# CITY OF ST. ALBERT

## BYLAW 2/2026

### LAND USE BYLAW AMENDMENT

Being Amendment 12 to Land Use Bylaw 18/2024

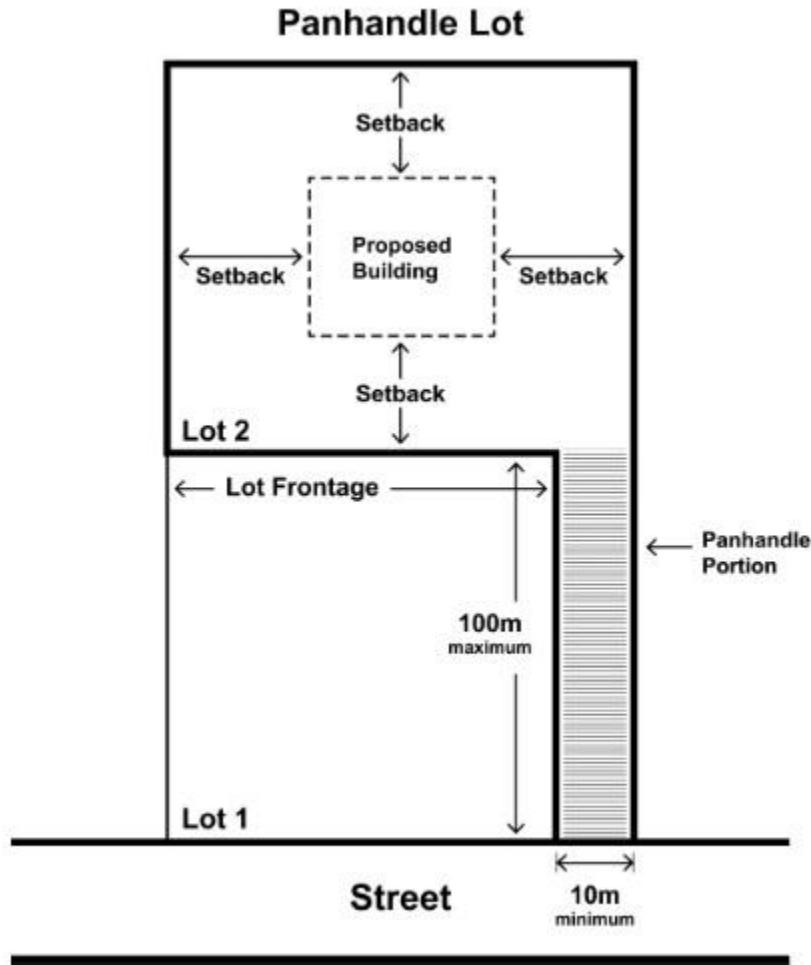
“(b) Notwithstanding section (4), *dwelling (single-detached)*, *dwelling (semi-detached)*, *dwelling (duplex)*, *dwelling (townhouse – single)*, and *dwelling (townhouse – plex)* are not required to provide *full cut-off light fixtures*.”
33. Section 3.26 is amended by deleting Figure 3-4: Panhandle Lot, and replacing it with the following Figure 3-4: Panhandle Lot:

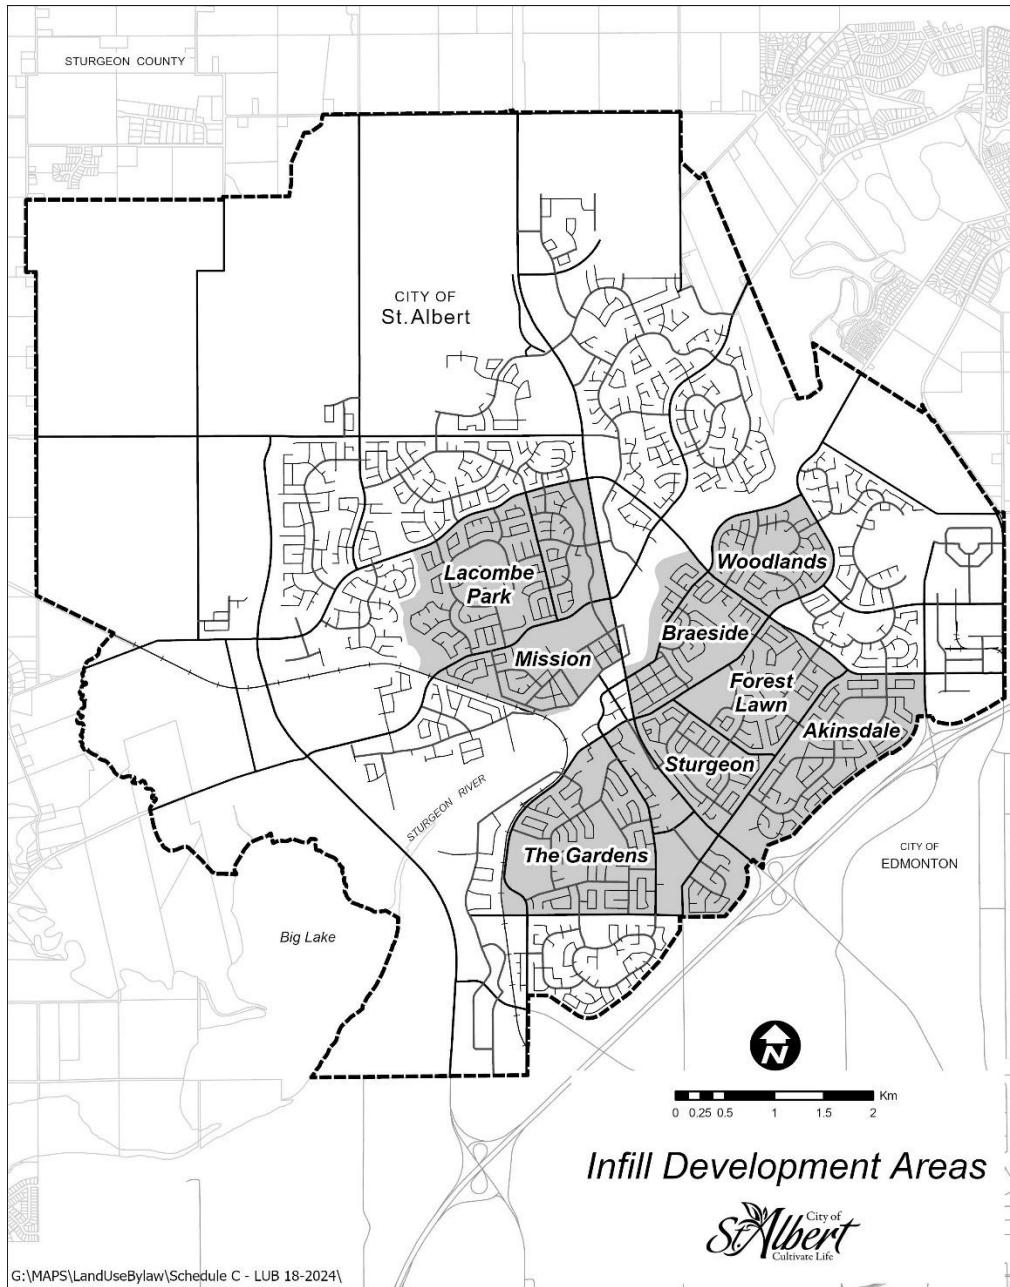
“Additional *development* requirements to ensure privacy for the adjacent *dwellings* may be required, at the discretion of the *Development Authority*.”
197. Schedule C, section C.12(3) is deleted in its entirety and replaced with the words “Intentionally Deleted.”
198. Schedule C, section C.12(4) is deleted in its entirety and replaced with the words “Intentionally Deleted.”
199. Schedule C, Figure 10-3 is amended by deleting the image, and its title, in its entirety.
200. Schedule C, Figure 10-1 (formerly figure 10-4): Established Neighbourhoods is amended by deleting the image, and replacing it with:

Housekeeping Redistricting - 710PUL St. Albert Trail

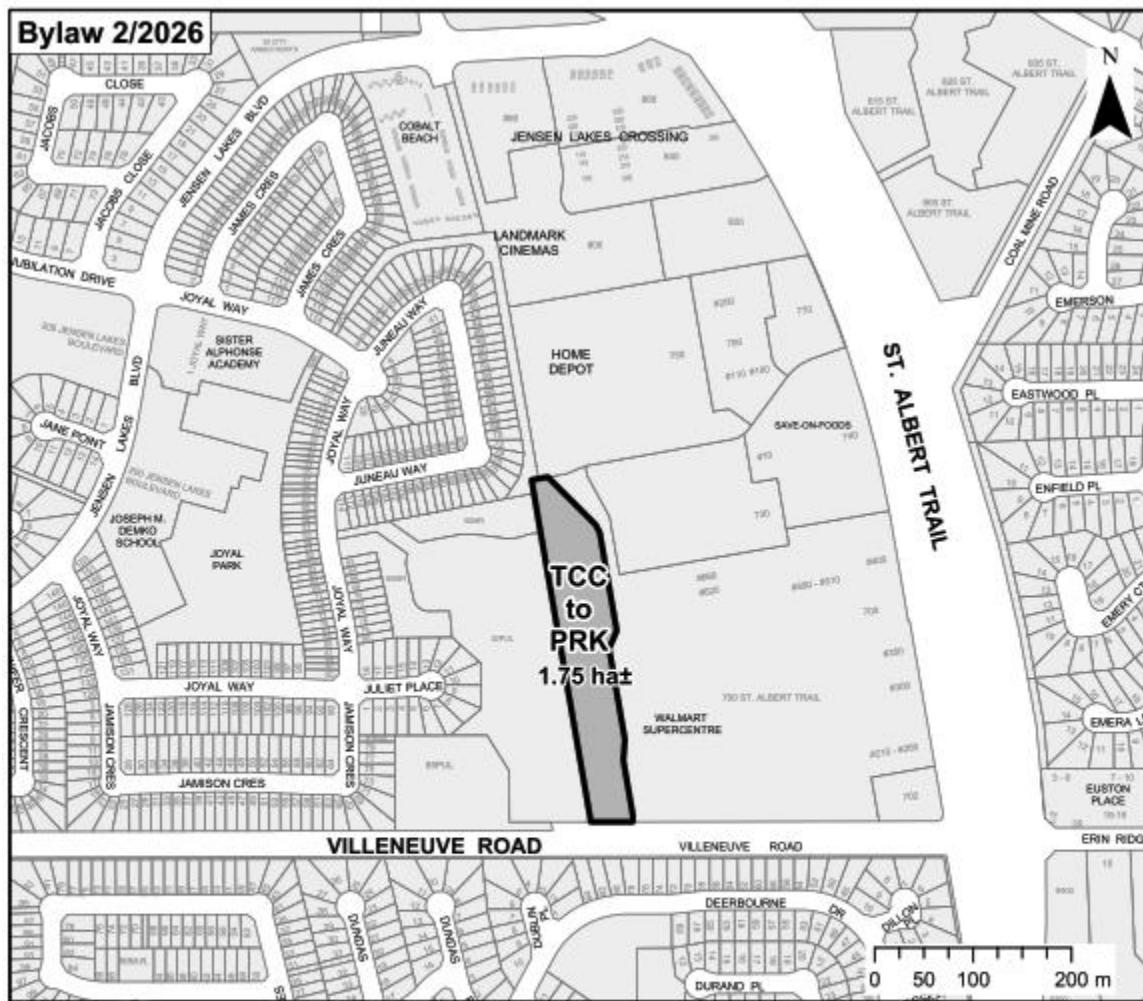
167. That a 1.75 ha portion of the lands legally described as Plan 012 4161, Block 1, Lot 4PUL (municipally described as 710PUL St. Albert Trail) are redistricted from the Trail Corridor Commercial District to the Public Park District, as shown on the map attached as Schedule "B" to this bylaw, and the Land Use District Map, being Schedule "A" to bylaw 18/2024 is amended accordingly.
